**IN THE MATTER** of the hearing by Thames-Coromandel District Council of submissions relating to the Thames-Coromandel Proposed District Plan in respect of Section 25 – Site Development Plans.

**STATEMENT OF EVIDENCE OF IAN JOHNSON  
on behalf of  
Hahei Holidays Limited**

- 2.1. I have read the Planning Officer’s report and recommendations. The specific focus of my evidence relates to Section 25.7, being the Site Development Plan for Hahei Holiday Resort. I will explain the reasons for HHL’s submission and I will explain my concerns with the recommendations relating to those provisions. In the context of those concerns I will suggest how the recommended changes should be amended.

Diagram C - Important Trees & Groups of Trees

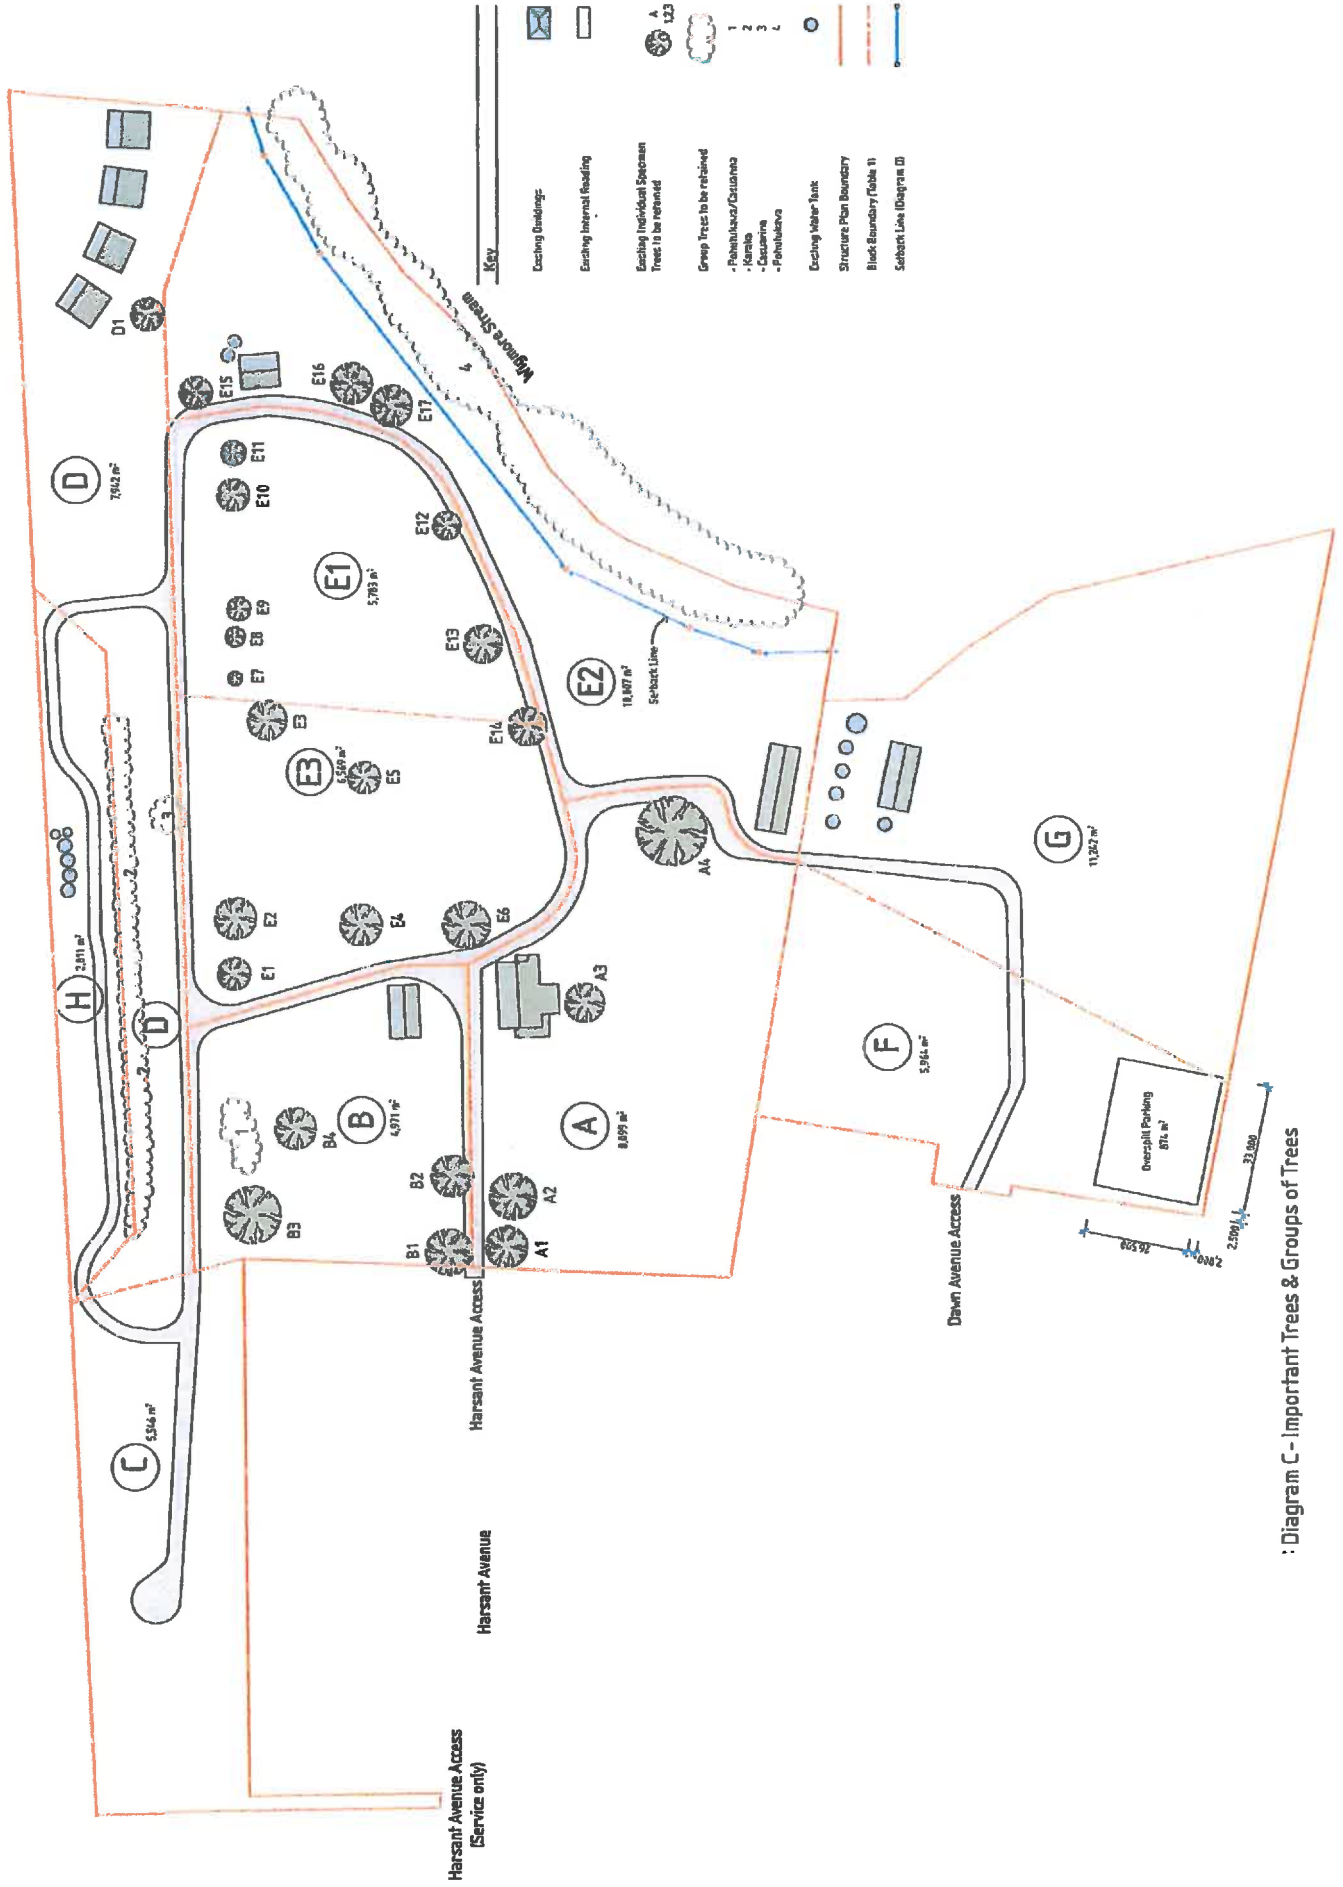
- 4.1. The Staff Report recommends the rejection of submission 411.19 which sought the inclusion of Diagrams C and D from the Operative Plan. These diagrams identify “important trees and groups of trees”, the extent and dimensions of an overspill car parking area that is required to be kept available for use for that purpose and also the extent of the defined setback line from Wigmore Stream. In relation to Diagram C, Plan Change 12 intended that it would be supported by a schedule which identified the species of the specific trees to assist their identification although I note the on-line version of the Plan does not include this schedule.

- 4.2. The reason for the Staff recommendation explains that the information shown on these diagrams is already shown on Diagram A within Section 25.7. I agree that Diagram illustrates trees and groups of trees but it does so at a scale that makes it difficult, if not impossible to identify a specific tree with any degree of precision. Even in its current form the Diagram would be improved by the schedule of trees that was originally proposed as part of Plan Change 12 but I note that this schedule is not proposed for inclusion. Without the schedule, the annotations on Diagram A are meaningless.

- 4.4. These are important matters which cannot be determined with any precision based on Diagram A of the Proposed Plan. In my view, the clarity of Diagrams C and D of the Operative Plan is preferable, albeit that I recognise that they could be combined to include

the schedule of survey points on Diagram C. With this amendment, and subject to the inclusion of the schedule of important trees and groups of trees, I consider that the clarity of the Plan provisions would be substantially improved. Improved clarity will be of benefit to all plan users and will potentially reduce compliance costs in establishing whether a proposal complies with the plan provisions.

- 4.5. I have included copies of the additional diagrams in Appendix 1 to my evidence. These also include an updated version of the Schedule of Important Trees and Groups of Trees which reflects works that have been undertaken in accordance with the Plan provisions since the Plan Change became operative.

Diagram D - Setback within Block E2

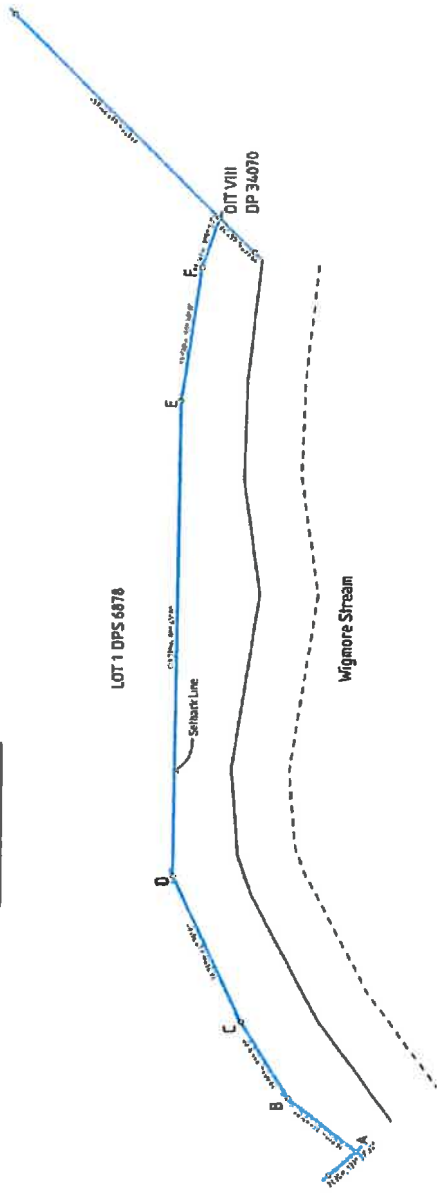
- 4.3. The proposed Diagram A also purports to define the overspill car parking area and the setback from Wigmore Stream. No dimensions are provided in relation to either matter, despite the fact that both were the subject of intense scrutiny at the Plan Change 12 hearing. In relation to the car park area, the Operative Plan identifies the precise dimensions and setback requirements to ensure that it would provide for its intended purpose without affecting the amenity of adjoining land. The Wigmore Stream setback was the subject of a specific site survey to define a building line that would avoid any significant adverse effects on the root system of the pohutakawa trees adjoining the stream. Diagram D of the Operative Plan provided the survey points and dimensions of the setback.

: Diagram B - Layout Plan for Block C

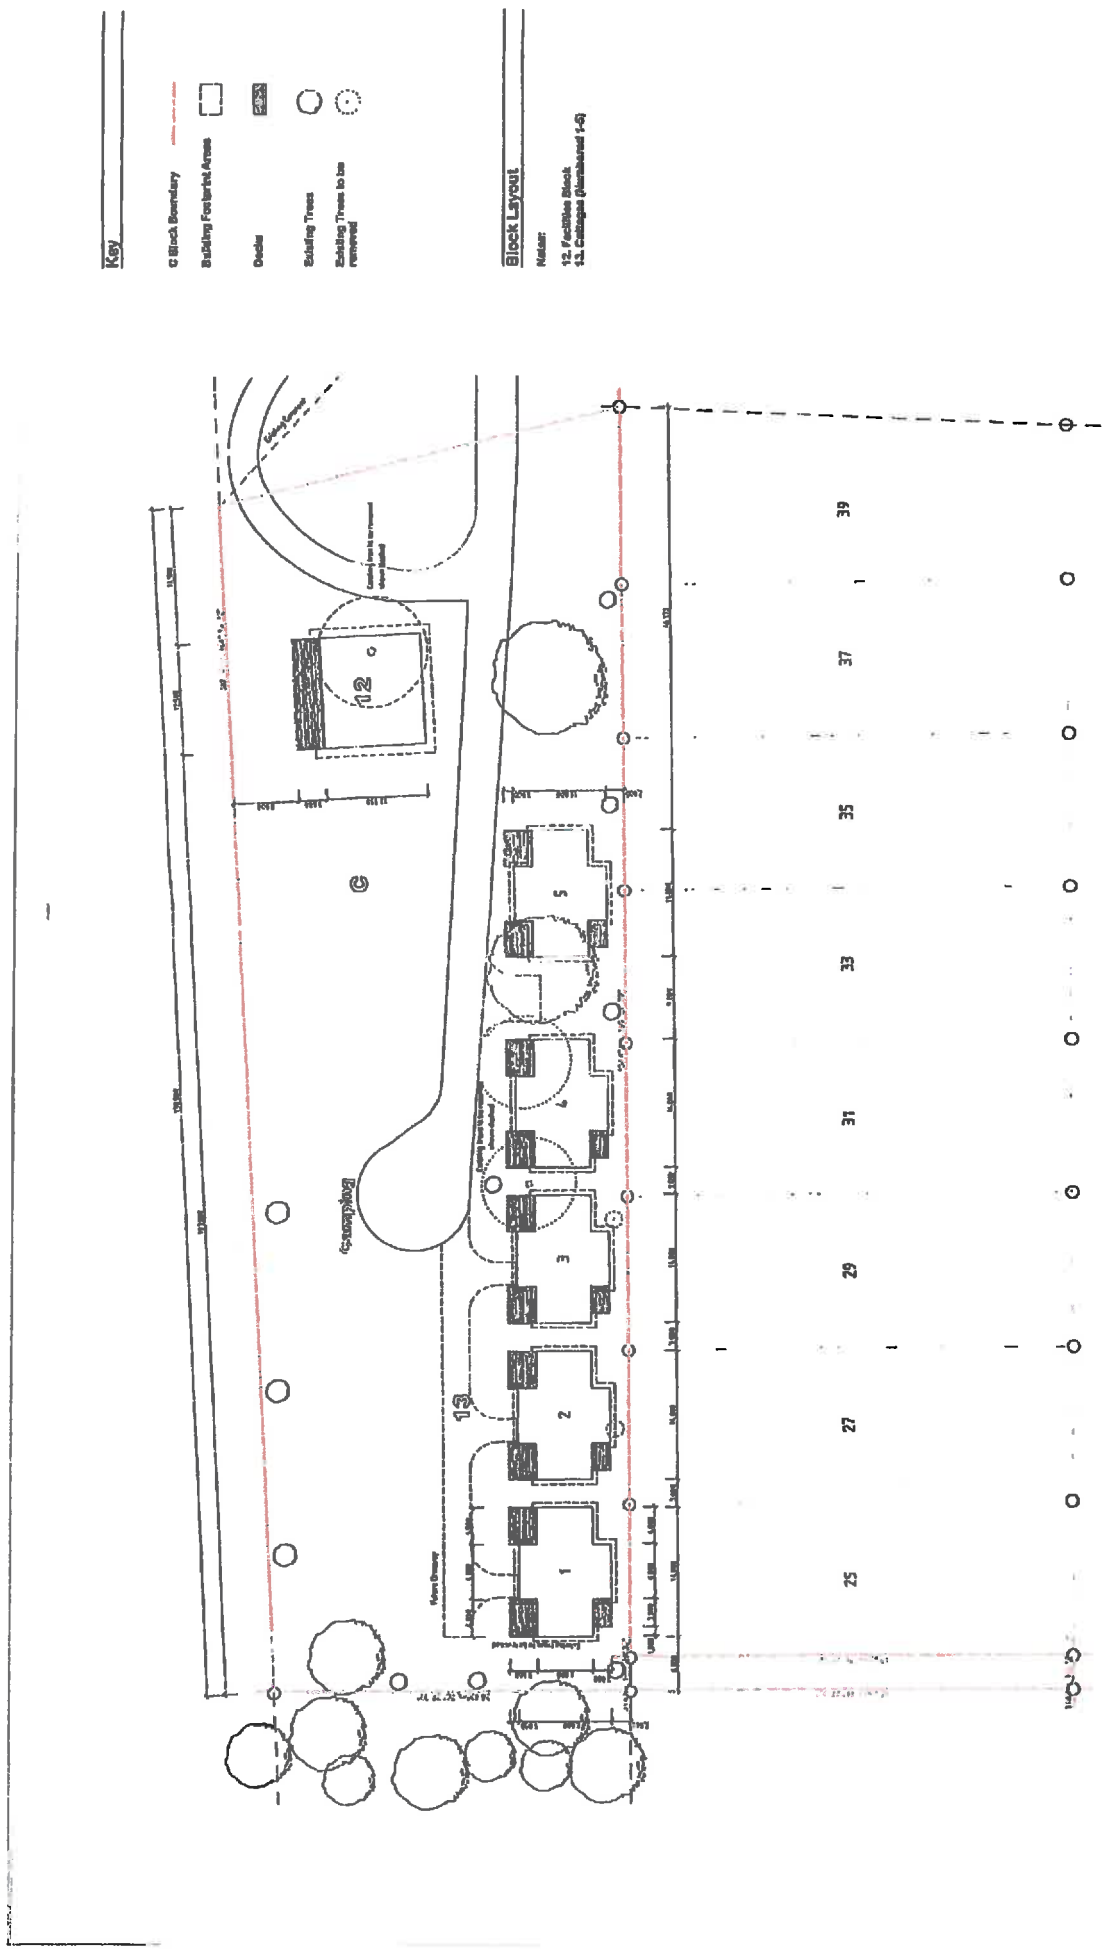
- 7.2. These provisions were derived from the consent order relating to Variation 3 and were subsequently incorporated into Plan Change 12. The proposed arrangement and positioning of the cottages was determined through negotiations which resulted in the consent order and was illustrated on a scaled diagram that was subsequently included as Diagram B to the Plan Change. That diagram now forms part of the Operative Plan and the cottages have been constructed in accordance with the setback requirements. I have included a copy in Appendix 2 to my evidence.

- 7.3. It has been translated into the Proposed Plan although, significantly, it has been the subject of amendments to remove the detailed dimensions that illustrate the effect of the agreed setback requirements. In my view, the removal of that detail is unhelpful. The diagram reflects a settlement that was agreed with TCDC and other parties and there was no dispute regarding the provisions or the detail of the diagram through the Plan Change 12 process. I am not aware of any evidential basis for amending the diagram or the setback requirements in respect of Block C.

- 7.4. HHL's submission simply sought clarity that these provisions would take precedence over the requirements of Rule 41.9 Table 5, Item 2 which would otherwise suggest a requirement for a 7.5m setback. I note from the Staff Report comments in relation to submission point 411.7 (which sought clarity regarding the relationship between the Site Development Plan Provisions and other provisions within the Plan) that reference is made to the Rules hierarchy which is explained in Section 1 of the Plan and in Section 25.1.3. The effect of this is that the setback requirements set out in Table 1 take precedence over those set out elsewhere within the Plan. While I am grateful for this relationship to be explained

- 7.5. While it seems clear to me that this recommendation is contrary to statements made elsewhere within the Plan, there is obviously potential for similar confusion to arise in the administration of the Plan provisions. In my view it would be helpful to reinforce the intended approach by expanding the last sentence of Section 25.7.1 to include the words:

*"..and the provisions of the Site Development Plan take precedence over those contained within zone, district-wide or overlay rules"*
